Re: SMB-911; Independent Cost Estimate for Decommissioning Muskogee Site

**FANSTEEL - ICF/NRC QUESTIONS
RESPONSE 1**

BLDG DIMENSIONS.dwg

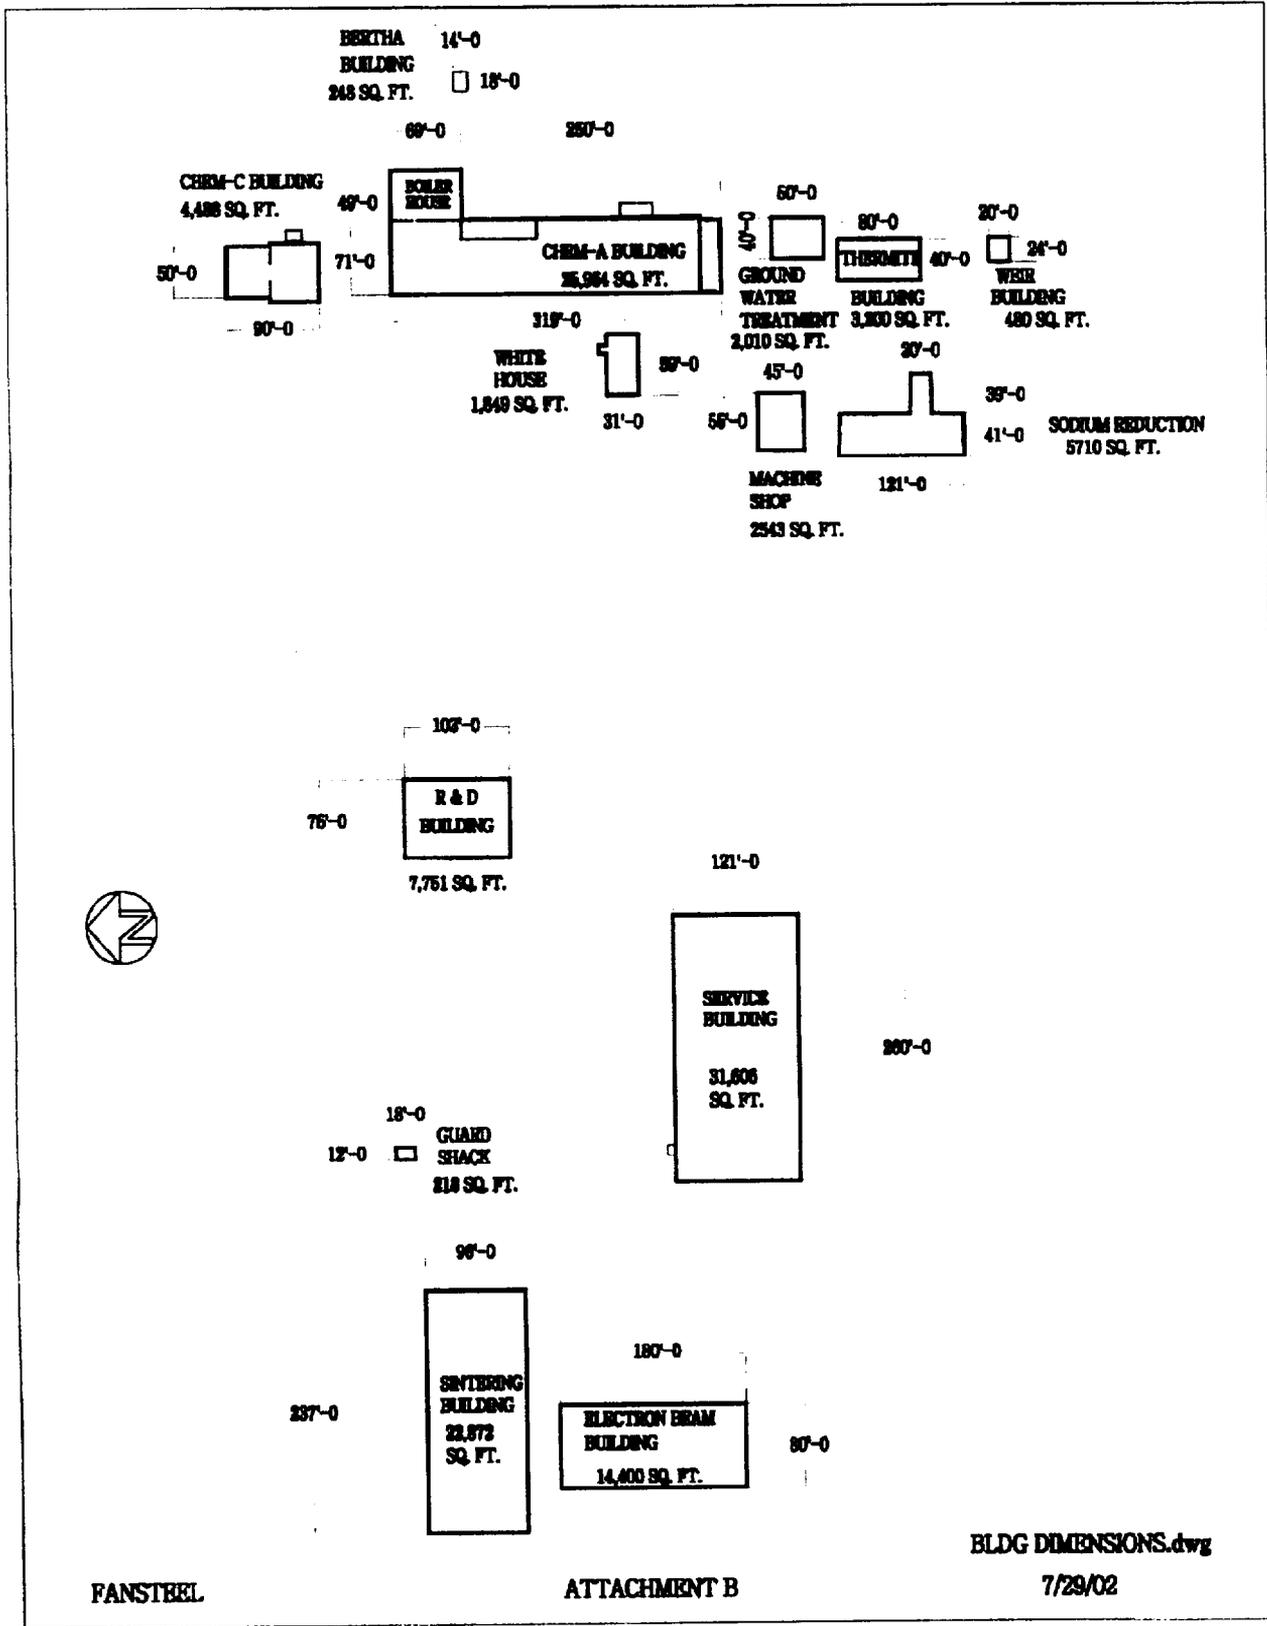
- 31. Which building on site is the "White House" (Building 7) and which is Building 10?**

Answer: See Attachment B, Building Dimensions.dwg, 6/20/02.
